ITEM FOR ENVIRONMENTAL COMMISSION AGENDA

NAME & NUMBER OF PROJECT: 3336 Mount Bonnell Road
SP-2020-0274D

REQUEST: Variance request is as follows:
Request to vary from LDC 25-8-281(C)(2)(b) to allow the construction
within 150-foot of a spring Critical Environmental Feature (CEF).

Staff Findings of Fact

PROPOSED CONDITIONS DOCK
LAYOUT/EROSION CONTROL

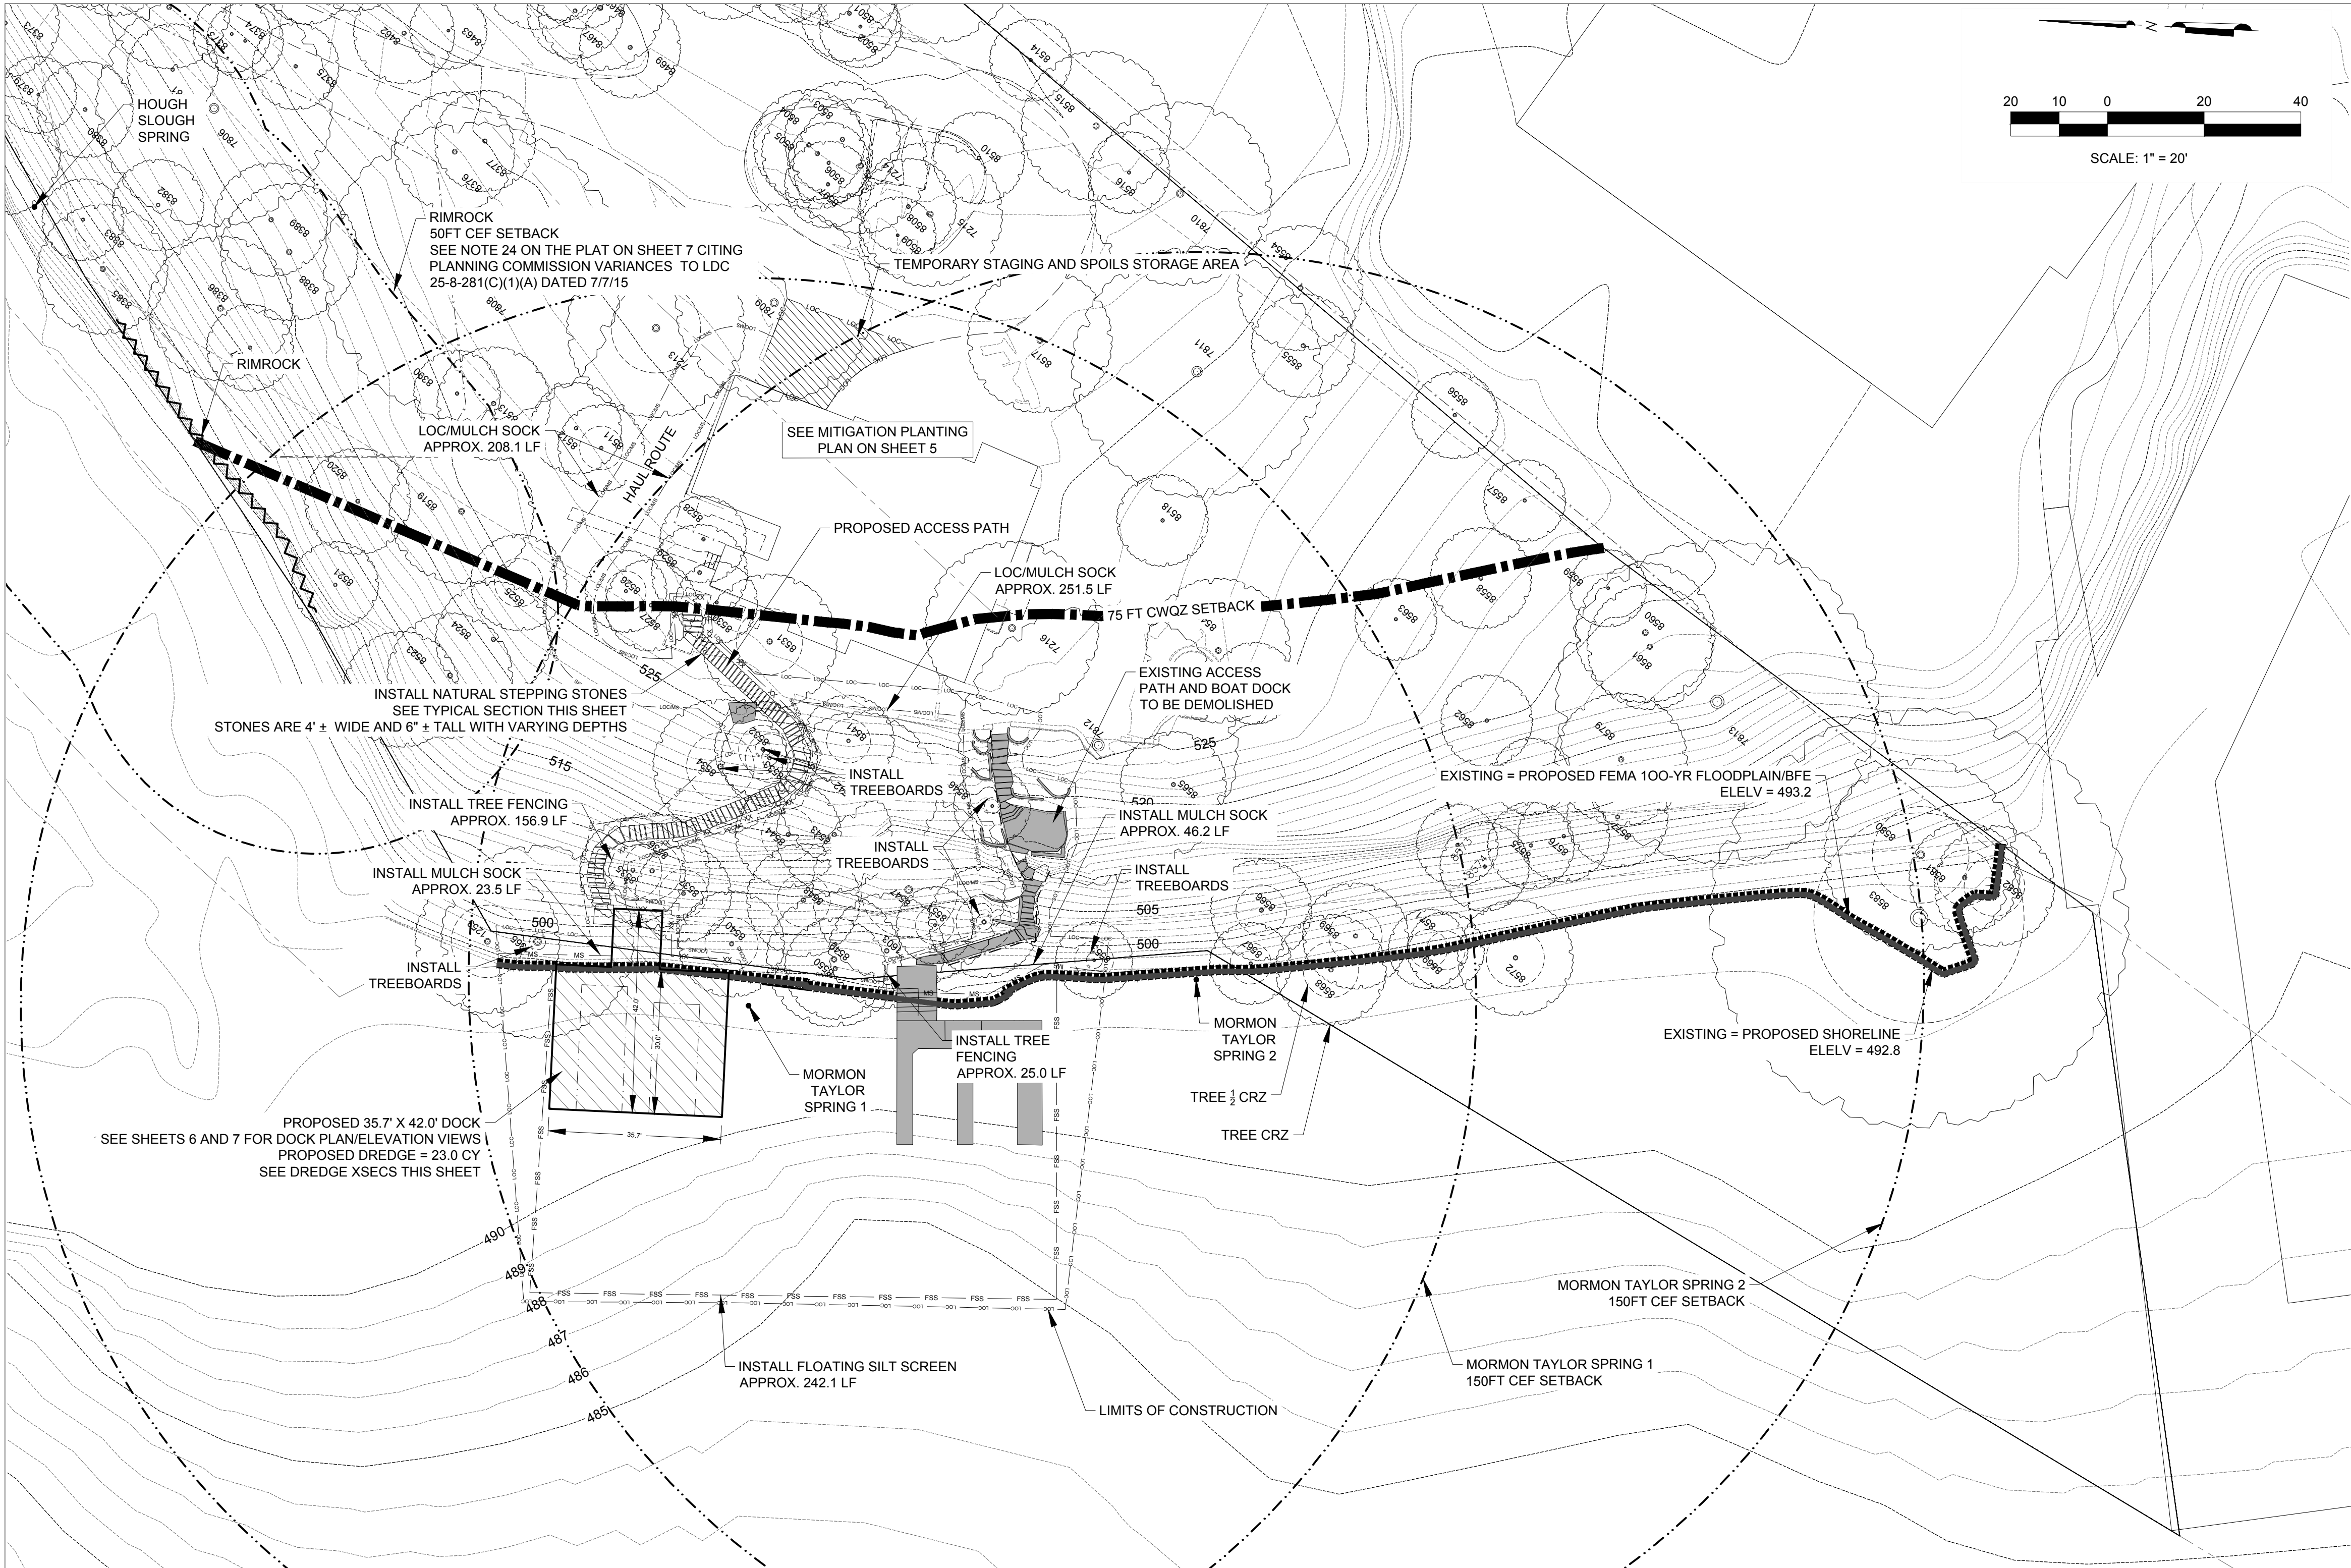
STAFF CONDITION: Remove existing boat dock and access path as specified on plans; restore
disturbed areas per City Standard Specification 609S.

Clearly indicate in what way the proposed project does not comply with current Code (include maps and exhibits)	<i>This project proposes to demolish an existing dock and its access and construct a new dock and access route in a less invasive location to the two springs on the lake Austin shoreline. The demolition of the dock and access as well as the construction of the new dock and access are within 150 ft. of two of the site springs. Please see Attachment 1 for the Proposed Conditions Site Plan and Erosion Controls Sheet.</i>
---	---
